## REQUEST

Current Zoning: R-17MF (multi-family residential)  
Proposed Zoning: UR-2(CD) (urban residential, conditional)

Approximately 1.53 acres located on the south side of Lynnwood Drive, west of Sterling Road, and north of Ridgewood Avenue.

The petition proposes to redevelop a site with 18 existing multi-family units to allow for the development of 21 new townhomes.

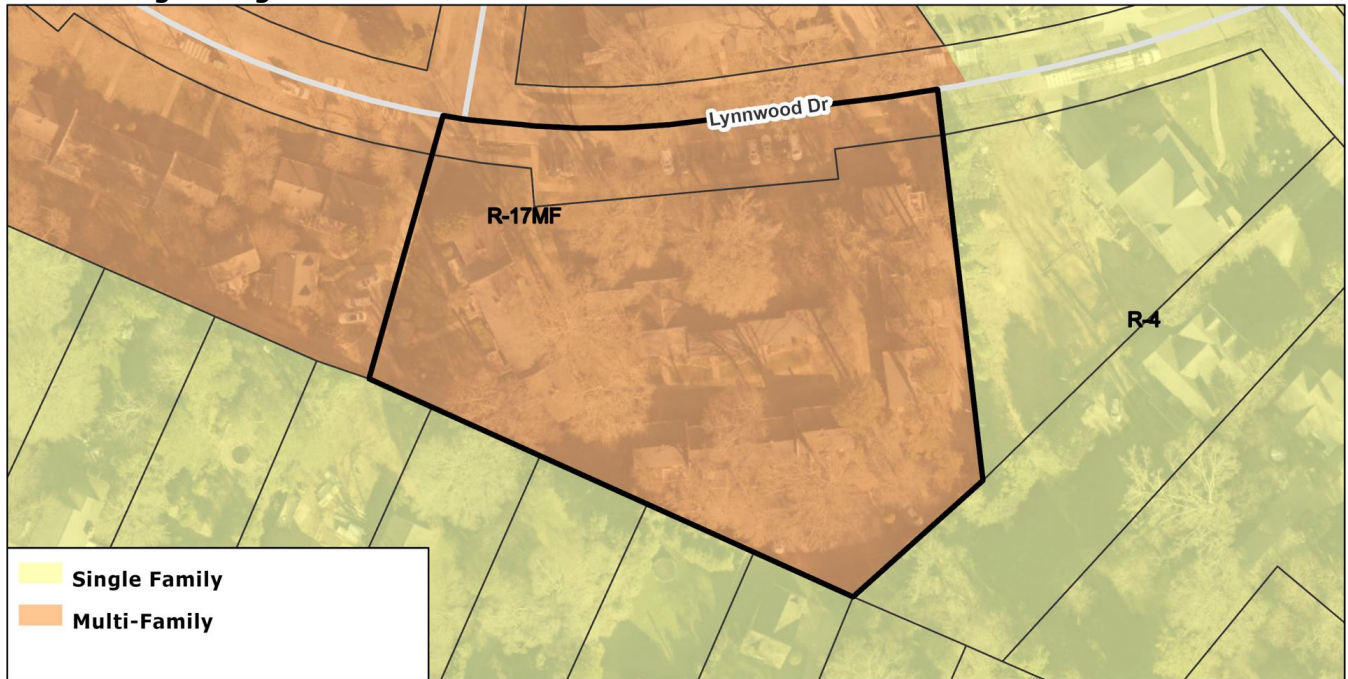
1. ~~Label and dimension the curb and gutter from the centerline for each road on the site plan. The site plan should show dimensions as measured from the centerline to the back of curb.~~ **Addressed**

2. ~~Remove language allowing additional height beyond 40' in note g. under Architecture and Design Standards.~~ **Comment Rescinded**

3. ~~Clarify in the conditional notes that the arborist plan will be done prior to development plan submittal and clearly identify which trees outside of the tree save area are to remain.~~ **Addressed**

4. ~~Add note that patios shall be at-grade and covered.~~ **Addressed**
5. ~~Add language in the conditional notes specifying that the open space requirement is being met with private open space, as shown on the site plan.~~ **Addressed**

6. ~~Revise the language in note 6 of Environmental Features to clarify the rate of new plantings to existing trees.~~ **Addressed**
